# PARTS & SERVICE NEWS

REF NO.	AA01115
DATE	June 29, 2001

**SUBJECT:** FAN GUARD MOUNTING REWORK

**APPLICATION:** WA800-2L Wheel Loader Serial Number A20001 through A20024  
 WA800-2LC Wheel Loader Serial Number A20021 through A20028  
 WA900-1L Wheel Loader Serial Number A20001 through A20010  
 WA900-1LC Wheel Loader Serial Number A20010 through A20023

Part No.	Part Name	Purpose	Quantity	Remarks
01	Seat	Replacement	2	See Fig. 1

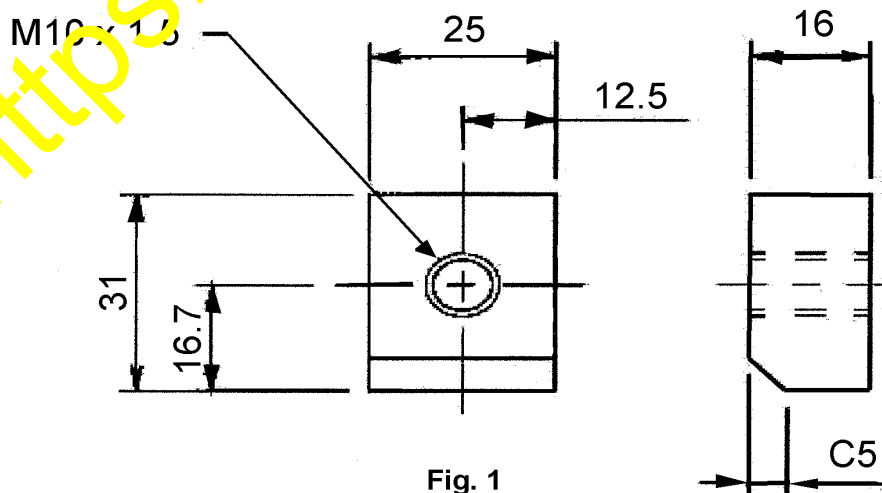
Part No.: 01

Part name: Seat

Material : SS400P

Qty : 2 / Vehicle

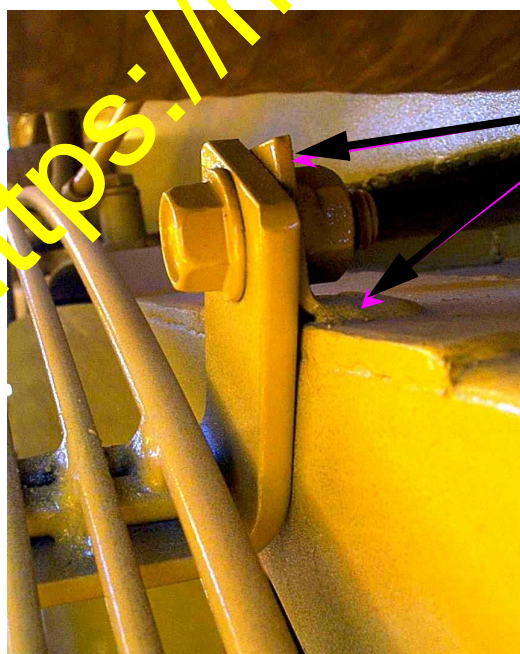
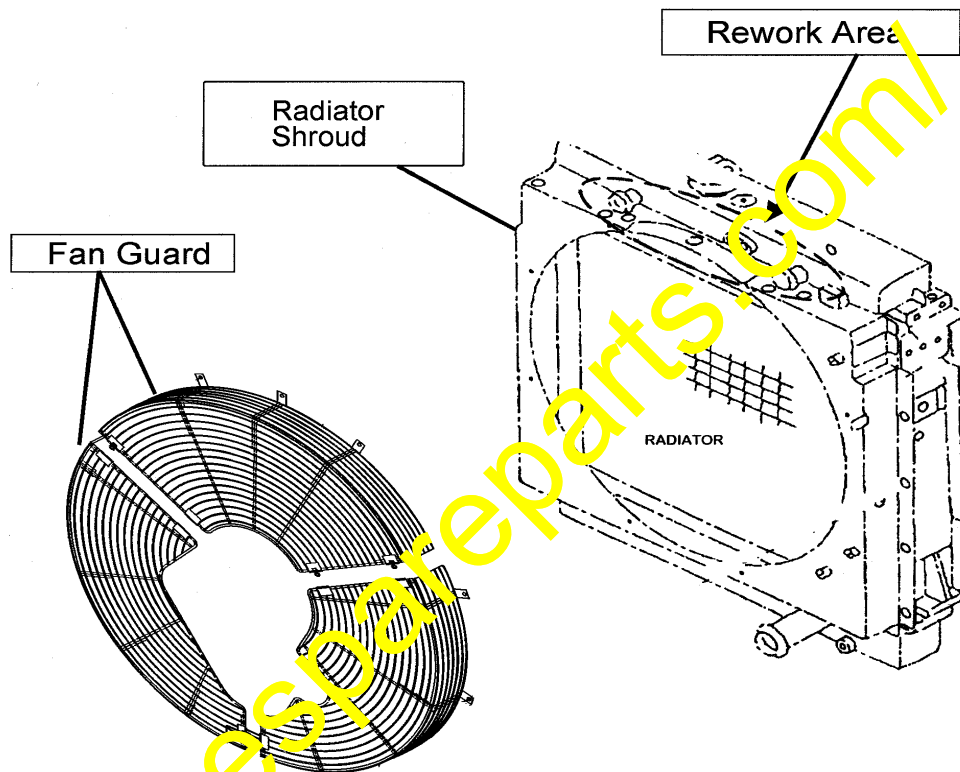
1. Uninstall fan guards from shroud.
2. Remove broken plates from radiator shroud  
(LH and RH, 2 places)

Remove the L-shape brackets,  
LH & RH from Radiator shroud  
and grind removed area to  
smooth.  
Photo shows LH side.

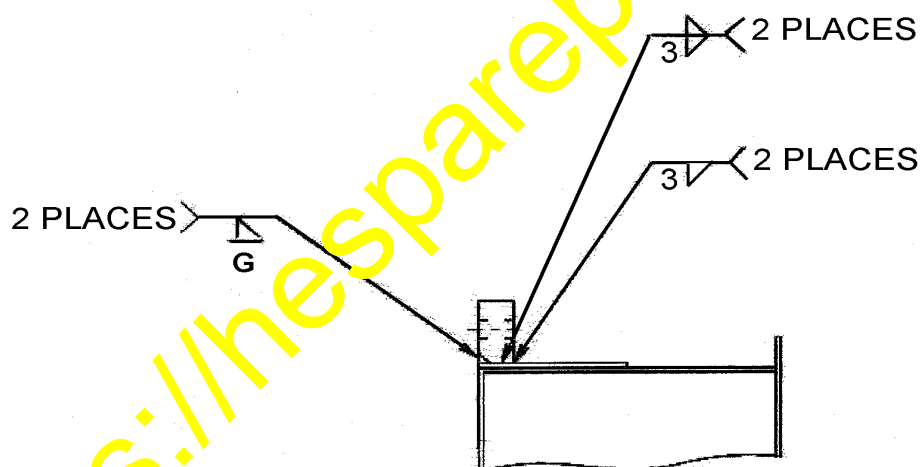
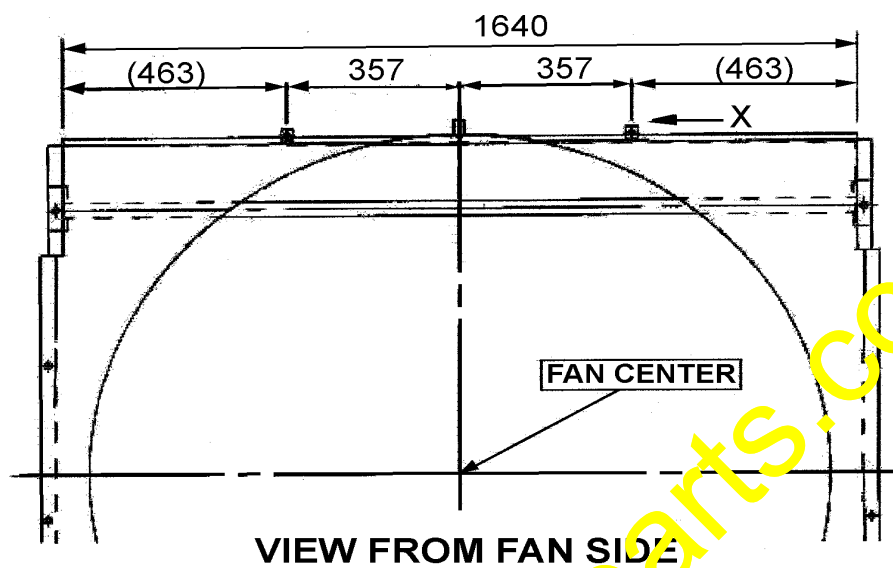
3. Weld new mounting block

Weld new seats as shown below.

Fan guards may be used for seat positioning.
